DSA CODE AMENDMENT DEVELOPMENT

Date Received:
DSA Tracking Number: 1
Date Reviewed: February 23, 2023
Status: Post CAC

Applicable Code Section(s): CBC Chapter 2, Section 202
Topic: Definition of BLENDED TRANSITION

**FIGURE 11B-406.3.2
PARALLEL CURB RAMPS**

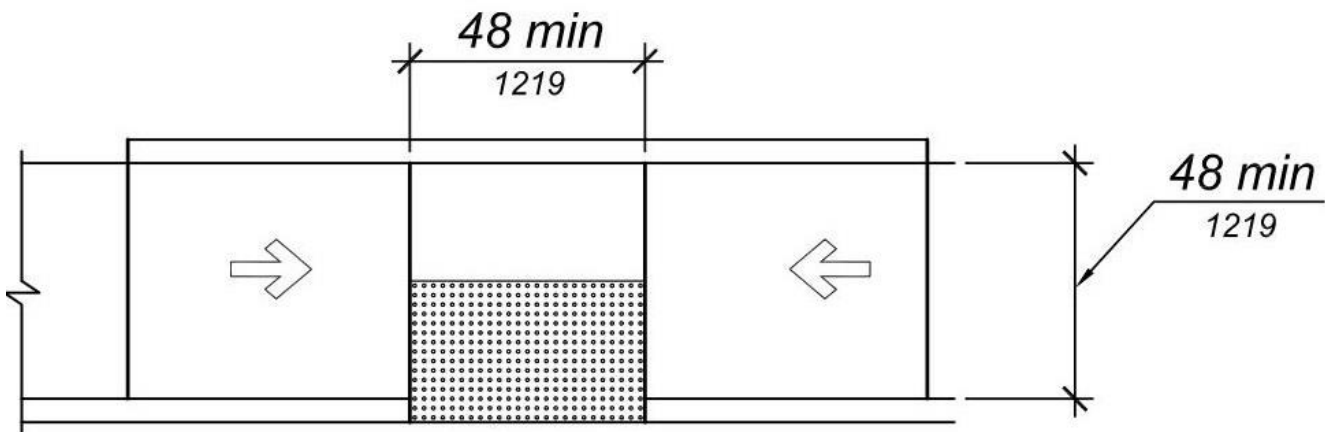
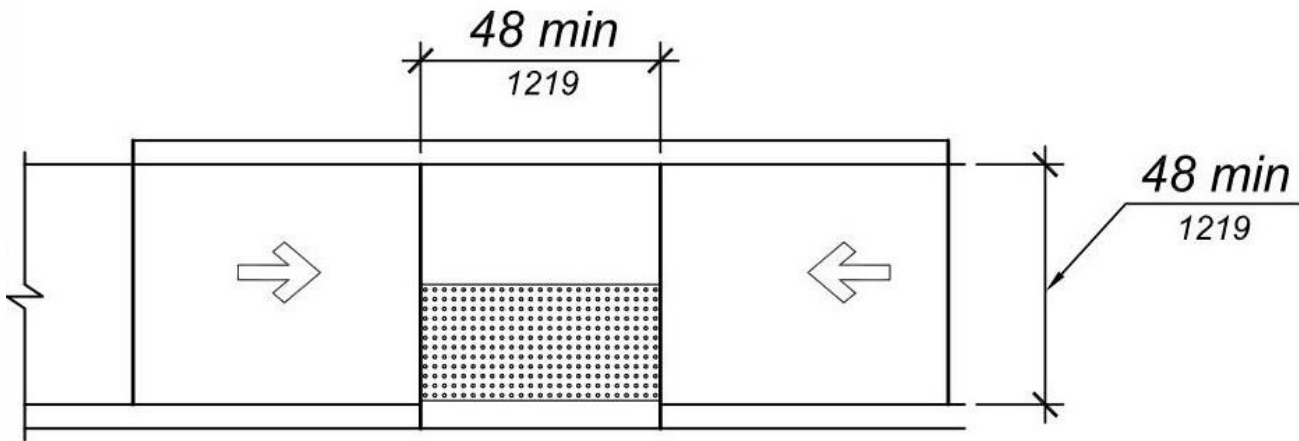
Applicable Code Section(s): CBC Chapter 11B, Section 11B-406.3.2
Topic: Parallel Curb Ramps

The location of detectable warnings at a parallel curb ramp bottom landing was changed in Section 11B-705.1.2.2.2 Parallel Curb Ramps, during the 2019 Intervening Code Adoption Cycle, to require detectable warnings to be located 6 to 8 inches back from the face of the curb. The corresponding figure for Section 11B-705.1.2.2.2 was updated, but the Figure 11B-406.3.2 was not updated and currently shows the detectable warnings at the face of curb. This change is proposed to correct the location of the detectable warnings to reflect the code language and make the two figures consistent.

**Figure 11B-605.5
Urinal Compartment**

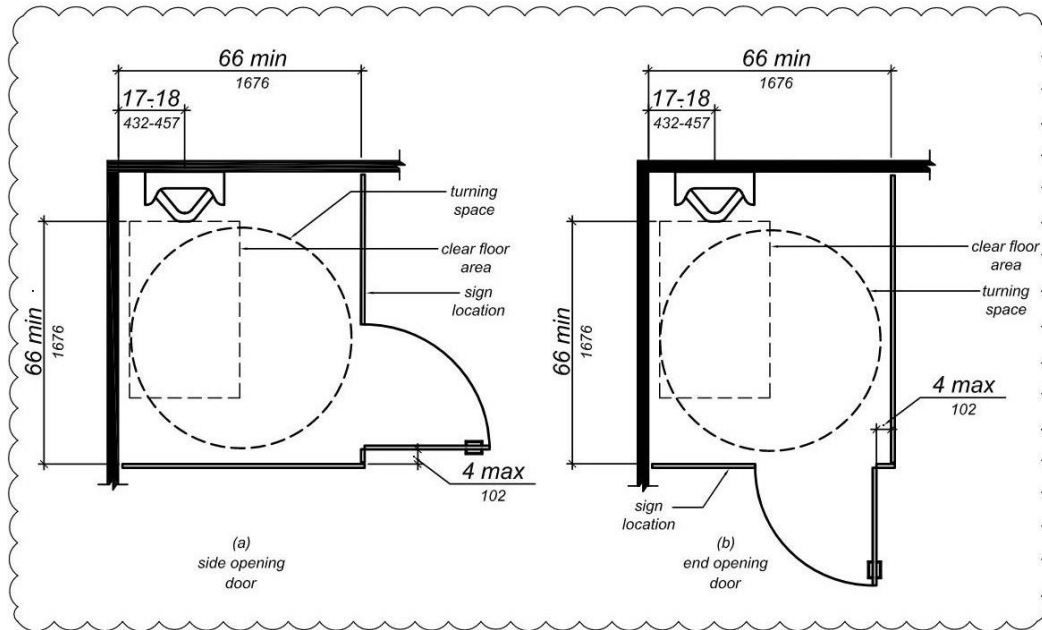
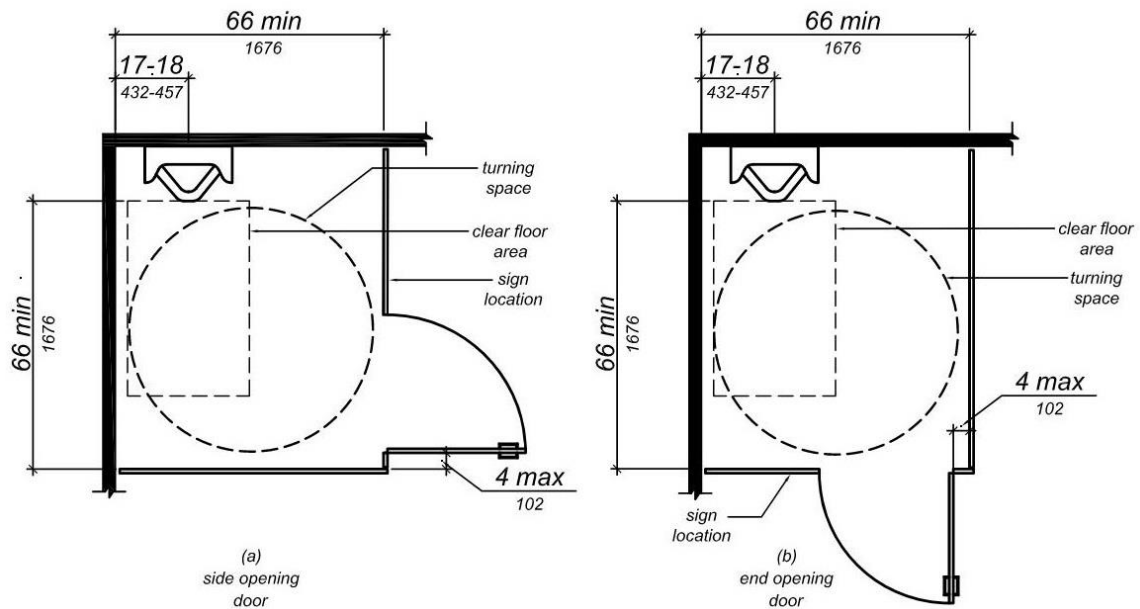
Exception: When located at the side wall or partition of a urinal compartment, the compartment door opening shall provide a clear width of 34 inches (864 mm) minimum.

11B-605.5.4 Toe Clearance. The front partition and at least one side partition shall provide a toe clearance of 9 inches (229 mm) minimum above the finish floor and 6 inches (152 mm) deep minimum beyond the compartment-side face of the partition, exclusive of partition support members. Partition components at toe clearances shall be smooth without sharp edges or abrasive surfaces. Compartments for children's use shall provide a toe clearance of 12 inches (305 mm) minimum above the finish floor.

Exception: Toe clearance at the front partition is not required in a compartment where the maneuvering clearance in front of the urinal is 66 inches (1676 mm) deep minimum. Toe clearance at the side partition is not required in a compartment greater than 66 inches (1676 mm) wide.

DSA is proposing scoping and technical requirements for accessibility in CBC Chapter 11B that will provide access to urinals located in compartments to include sufficient clear floor space and maneuvering space for a person using a mobility device to enter the compartment, use the urinal, turn around, and exit the compartment. A figure is proposed to illustrate the requirements.
